Detailed Site Plan
Departure from Design Standards
Alternative Compliance
ALTA Woodmore

DSP-22034
DDS-22002
AC-23001

SUBJECT: Detailed Site Plan DSP-22034
Departure from Design Standards DDS-22002
Alternative Compliance AC-23001
Type 2 Tree Conservation Plan TCP2-053-07-06
ALTA Woodmore

Figure 3: Proposed Building-Mounted Signage

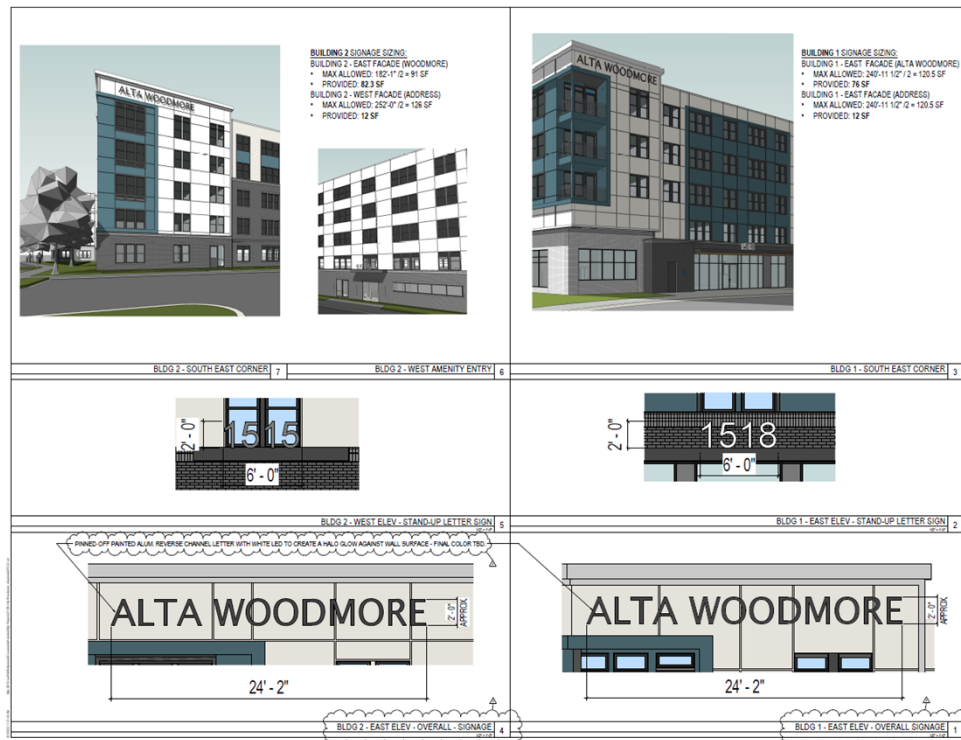
approximately 182 square feet of building-mounted signage that falls within the maximum square footage allowed under the C-S-C Zone and, therefore, the proposal is found to be reasonable and consistent with signage in other commercial zones throughout the County. As referenced earlier, conditions have been included herein, requiring the applicant to provide a signage schedule on the DSP coversheet, to revise the freestanding sign stand material from stone to brick, and provide attractive understory landscaping for the freestanding sign.
